March 27, 2015

**Subject: Century Tire Plaza – 195 Kennebec Street
Project ID# 2015-027
Review Comments Received March 24, 2015**

SHEET TITLE: **SITE LAYOUT AND UTILITY PLAN**

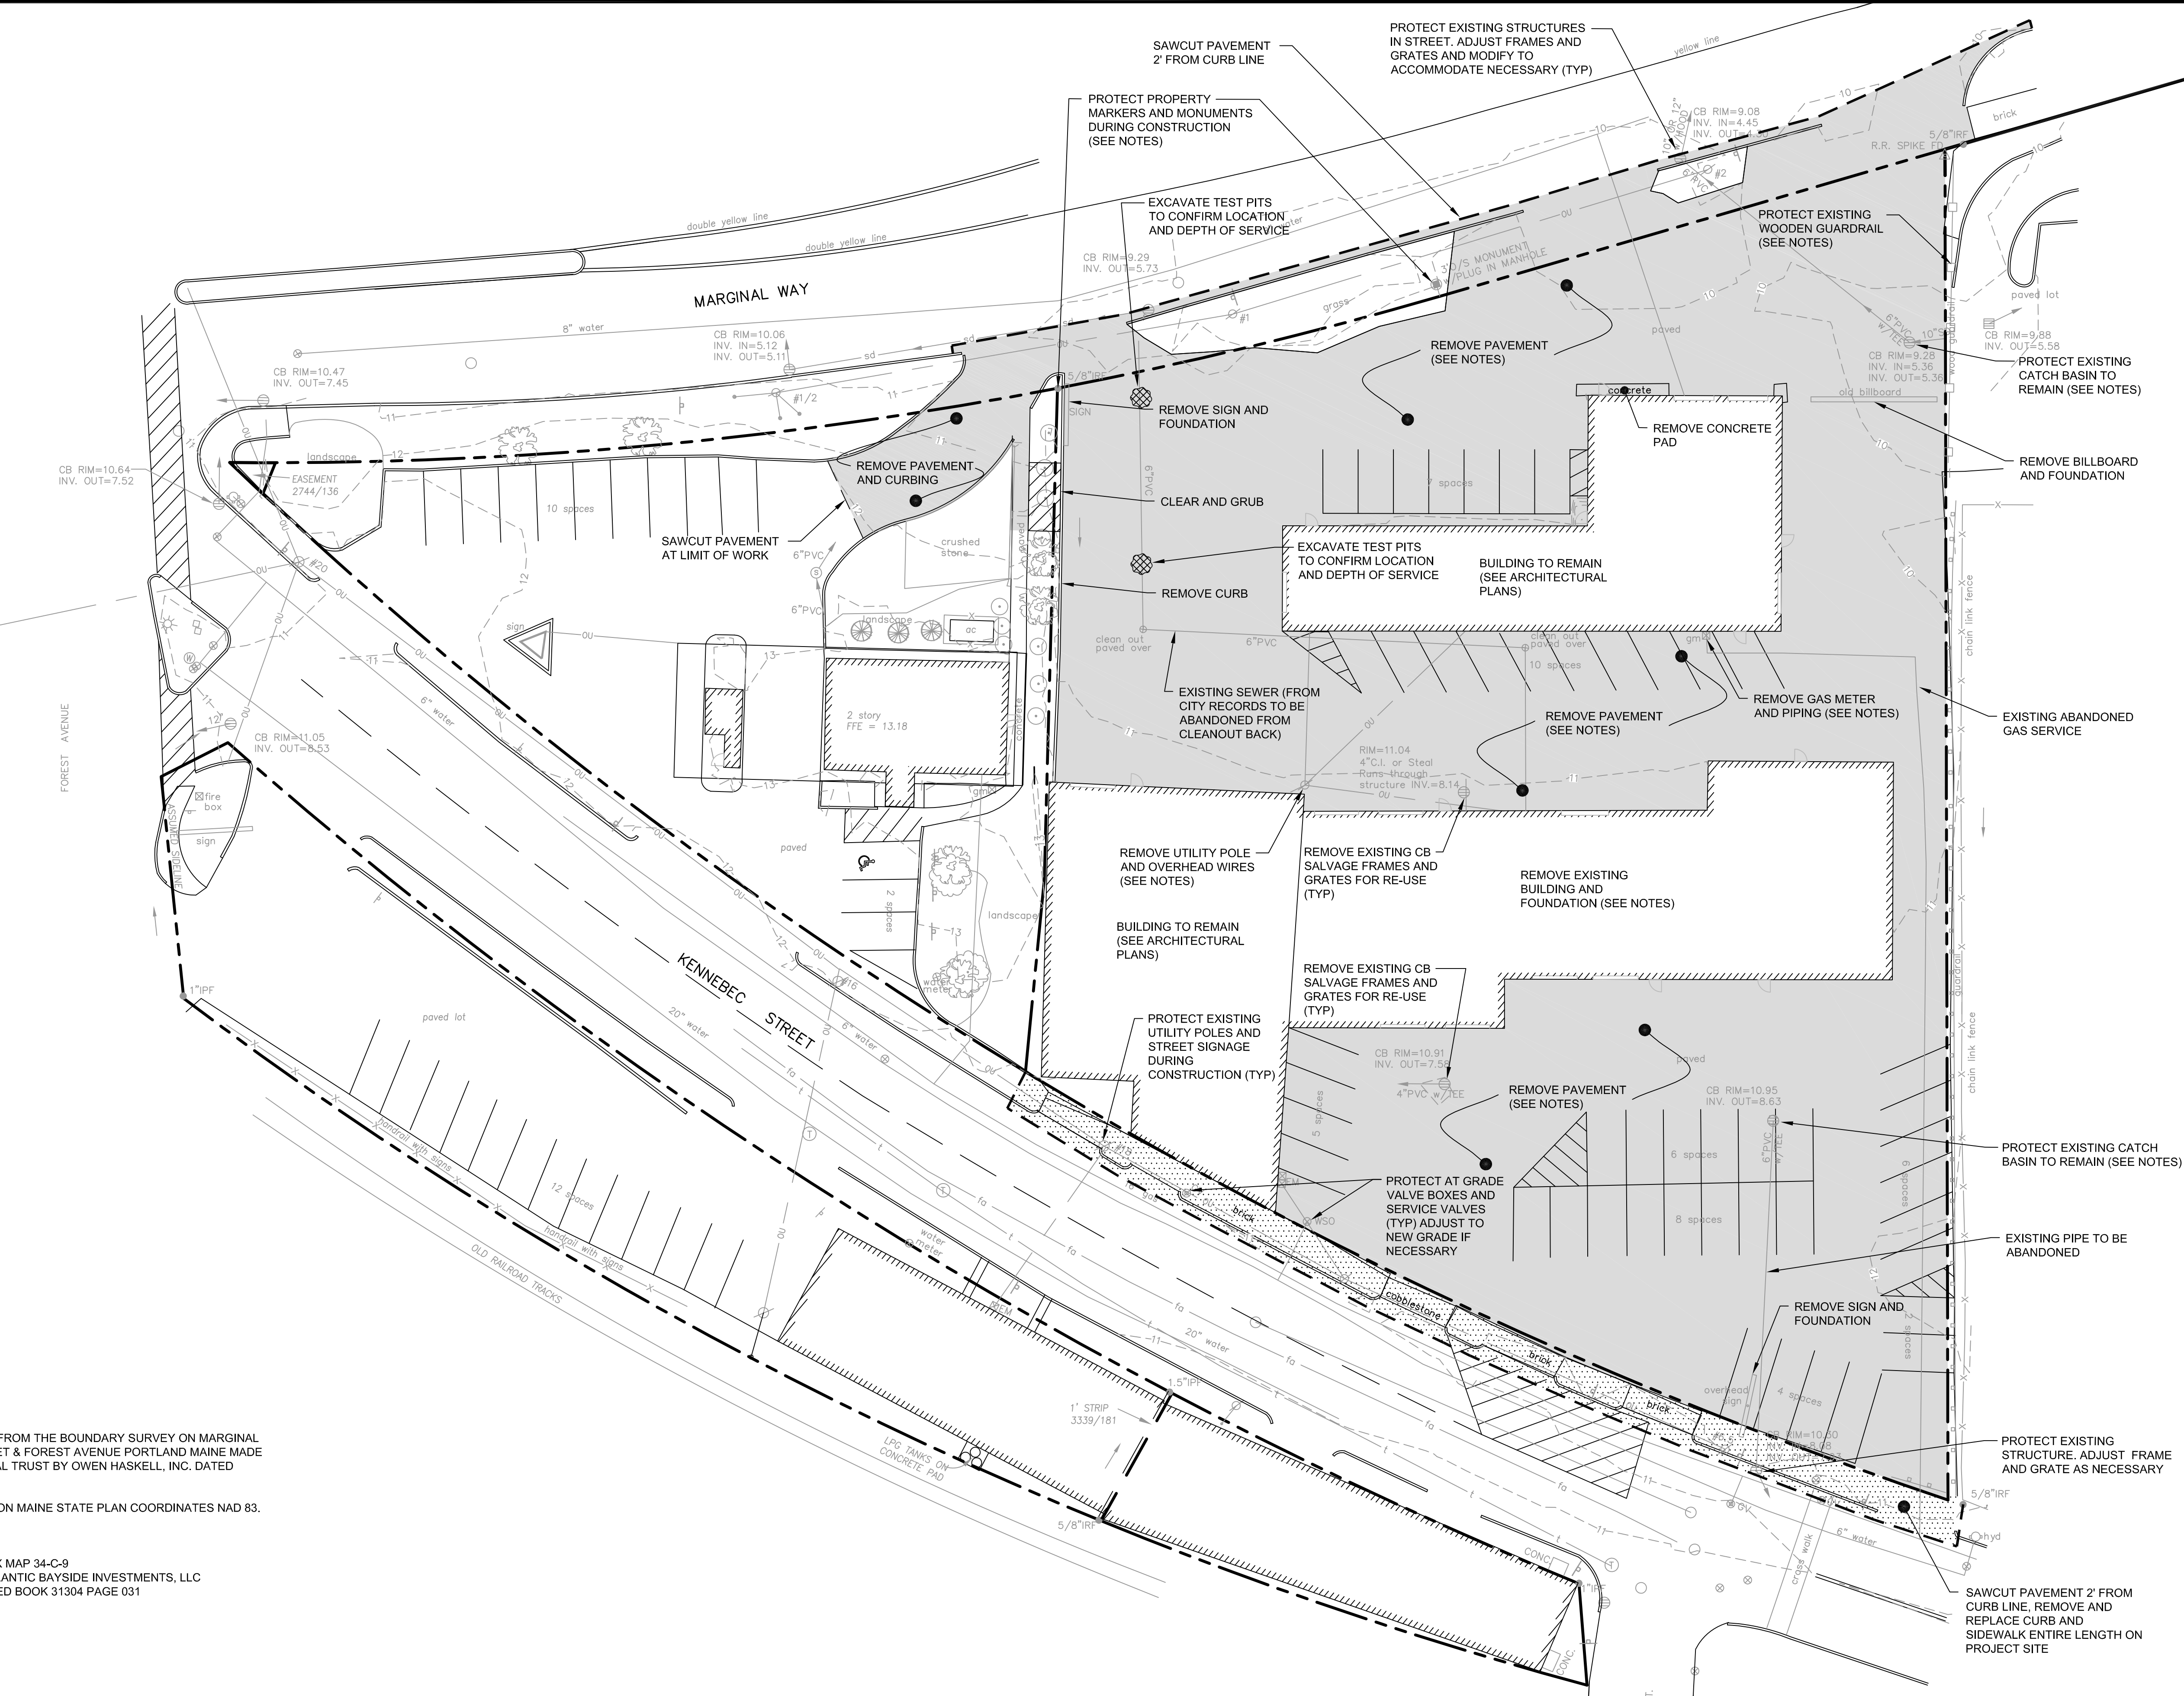
The curbing material standard within the road right of way for the City of Portland is granite. Concrete is indicated on Kennebec St.

Stop bar locations shall be placed prior to sidewalk at the driveways.

Detectable warning panels are not required at driveways.

The label for the proposed curbing material has been changed to indicate granite curbing at this location.

Stop bar locations have been revised in response to this comment and the warning pavers have been removed.

2 | BUILDING A SOUTH ELEVATION
 1/8" = 1'-0"

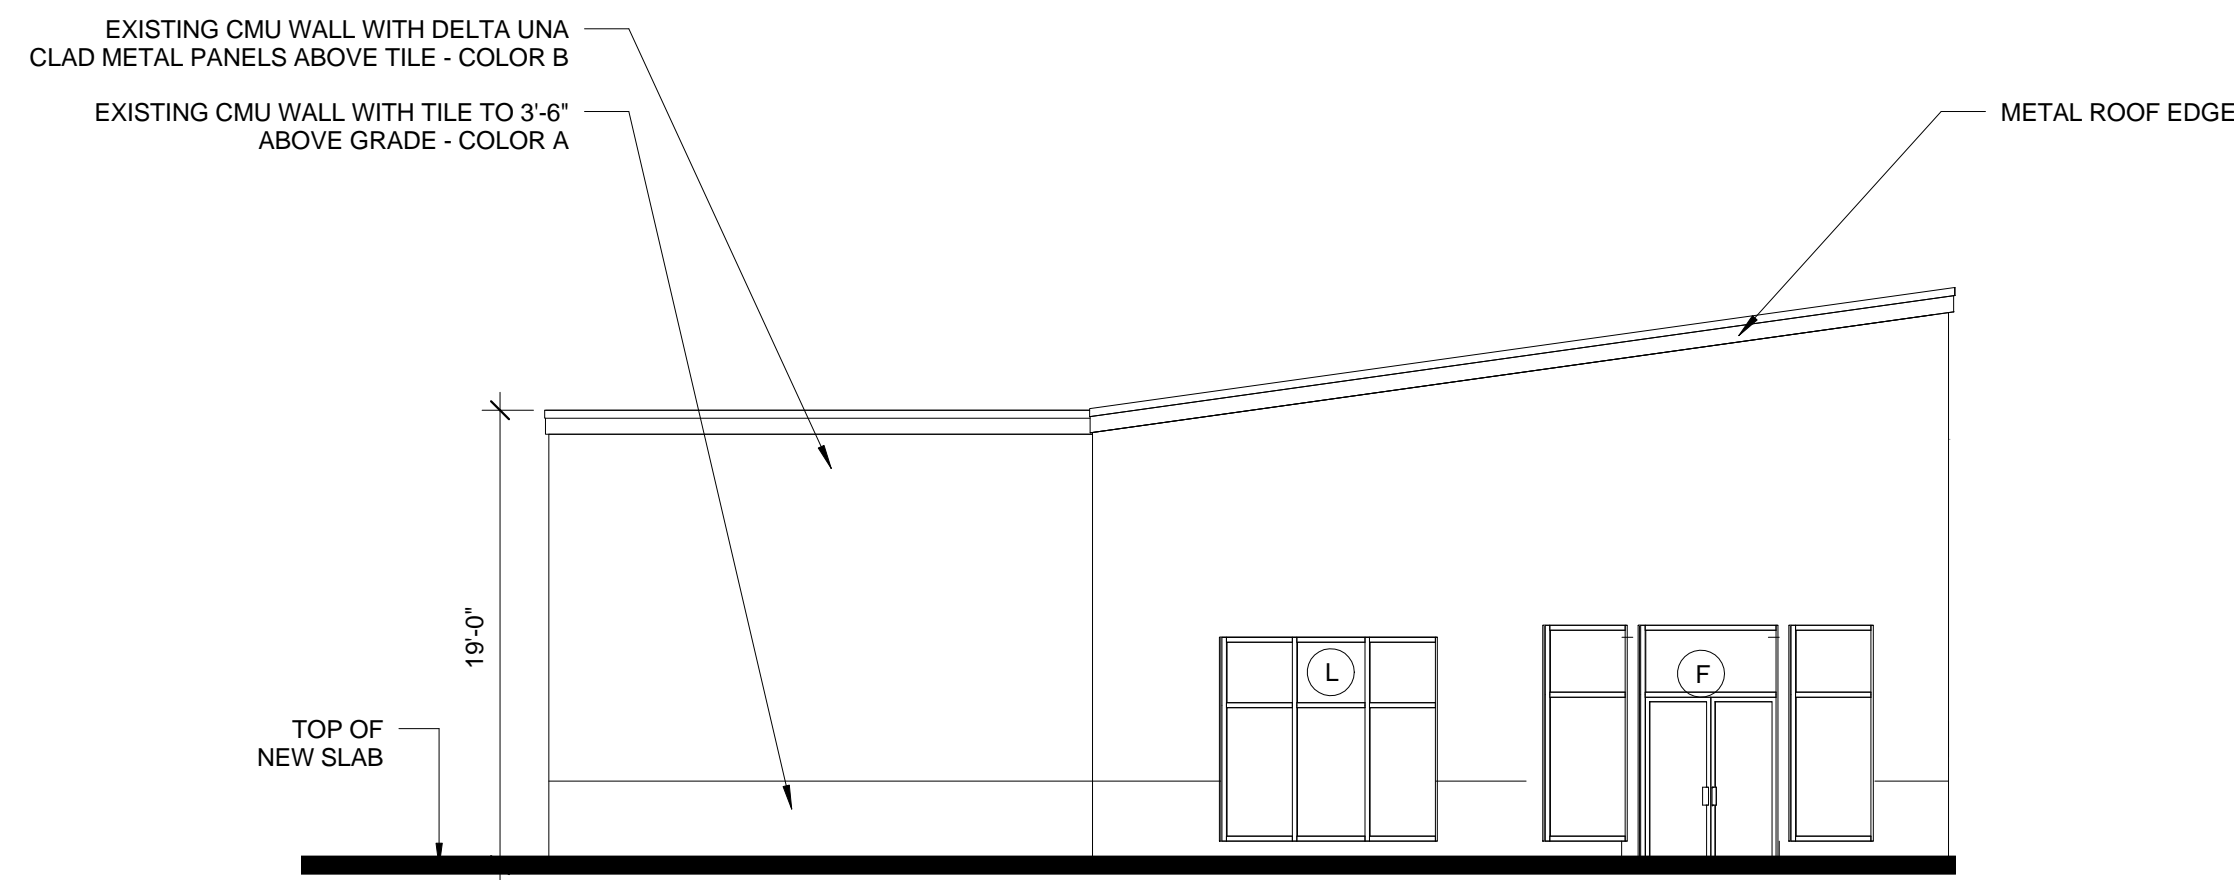
- *Building A South Elevation, which faces Kennebec Street, should be revised to provide windows.*

This was discussed at the meeting on March 25, 2015 and the plans for Building A have been amended to show a revised façade and an entry on Kennebec Street.
